Design Review Board Meeting

Tuesday, November 14, 2023, 3:00 PM

Below is a summary of the comments addressed from conceptual DRB review of DPB-001710-2023 – 20 Olive Shell Court, Olive Shell Cottages Development. Sheet set dated November 8, 2023.

ELEVATION SHOWING TYPICAL FLOOD VENT LOCATIONS

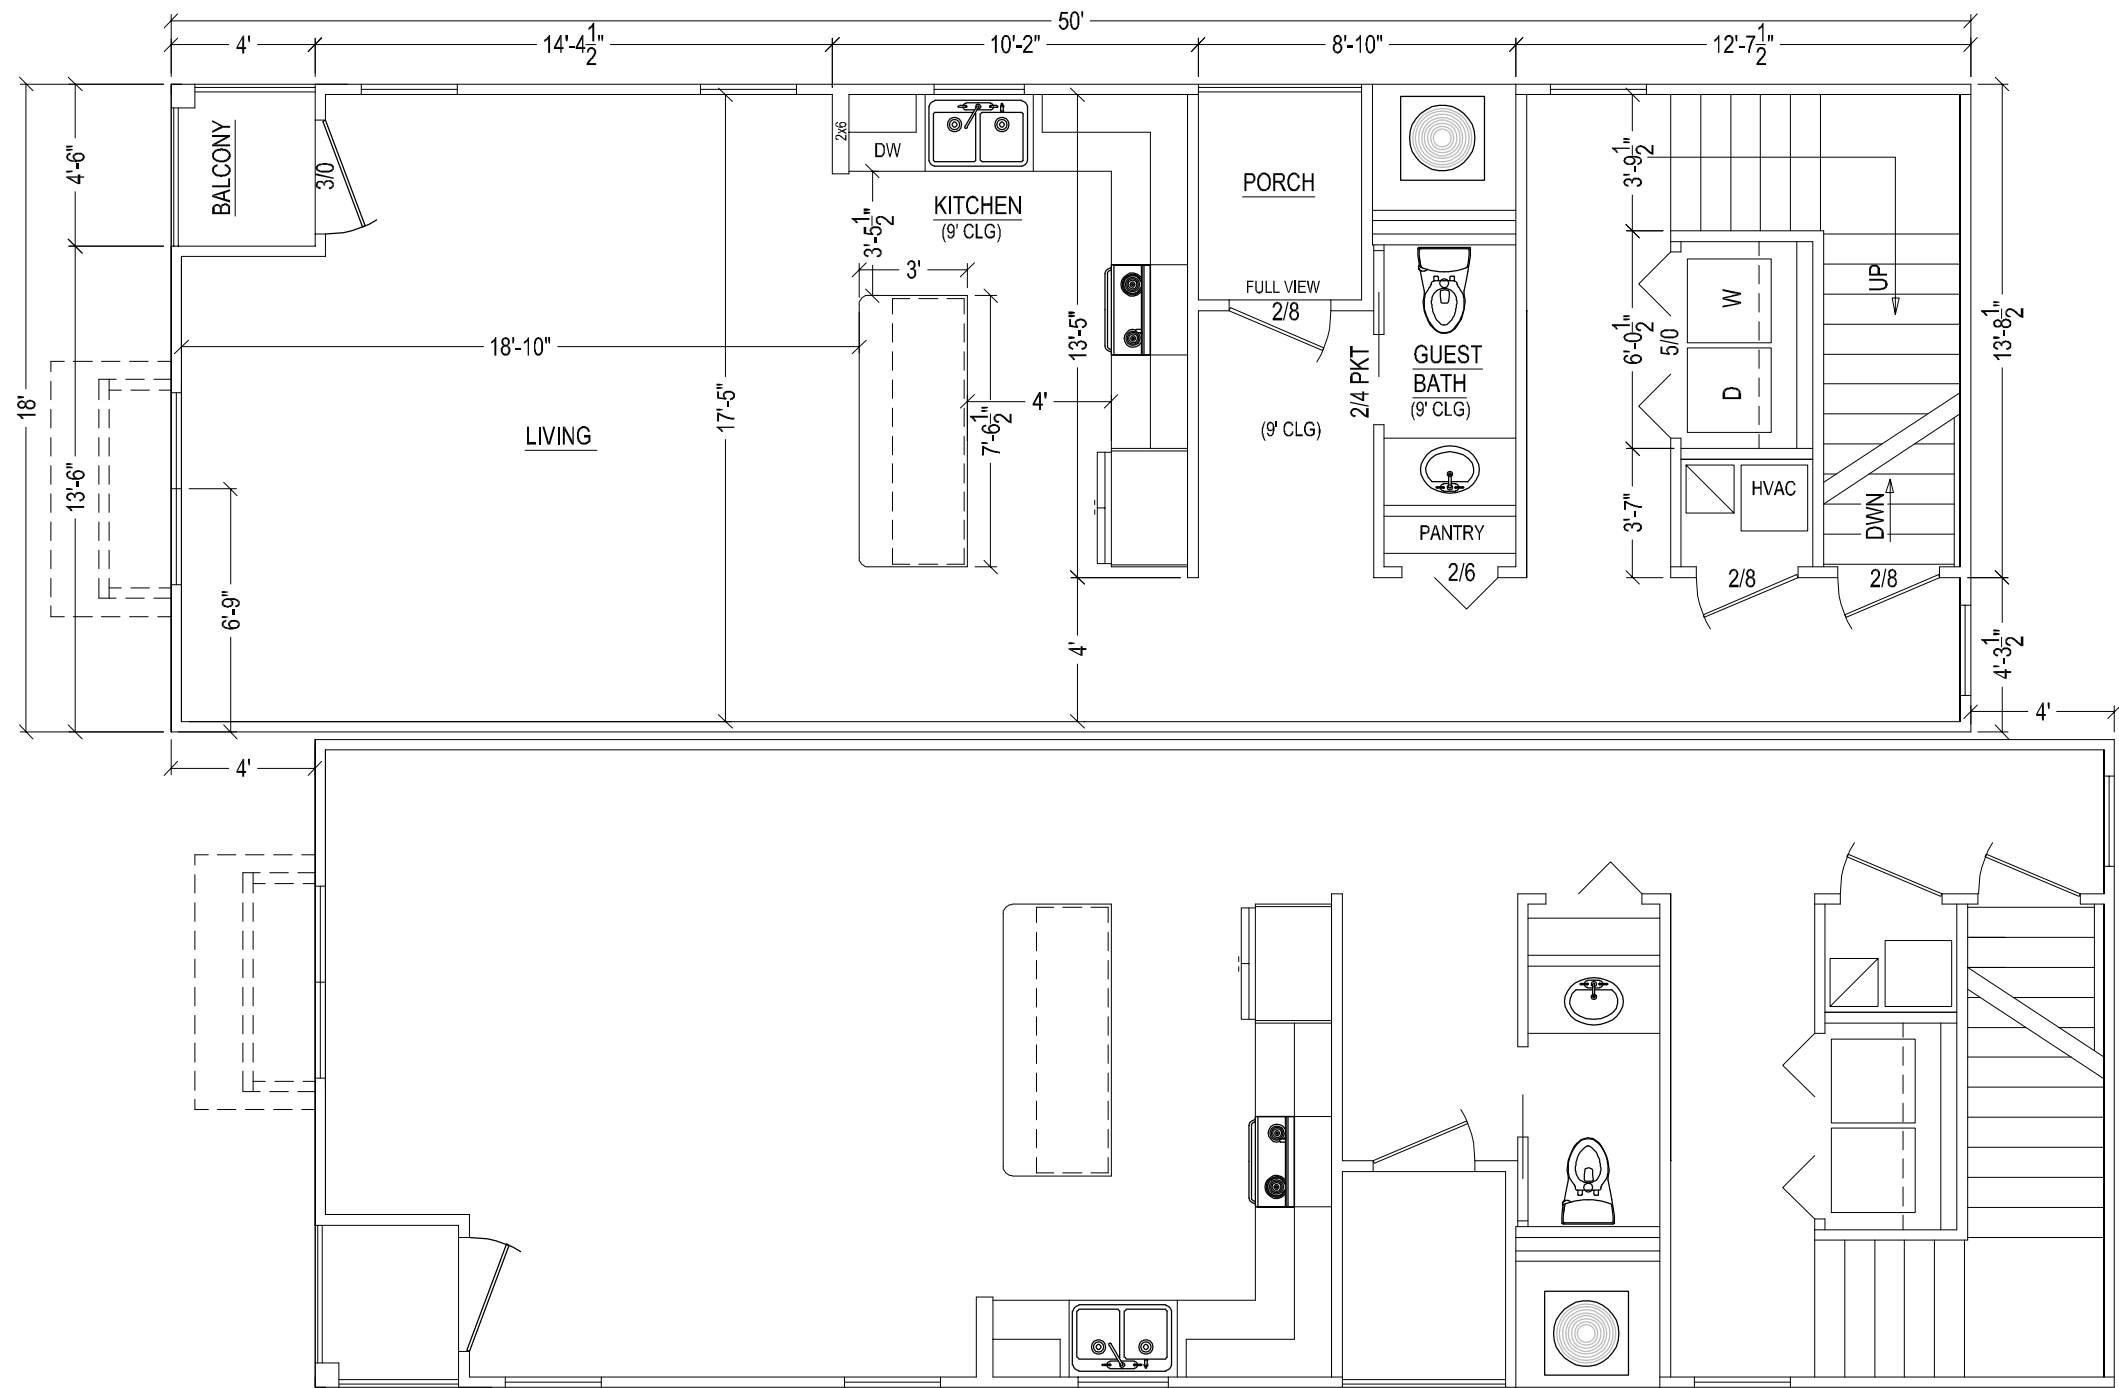
DRB Condition #10 – Flood vents added to building plan set. See Building rendering. Will be included per Building Code.
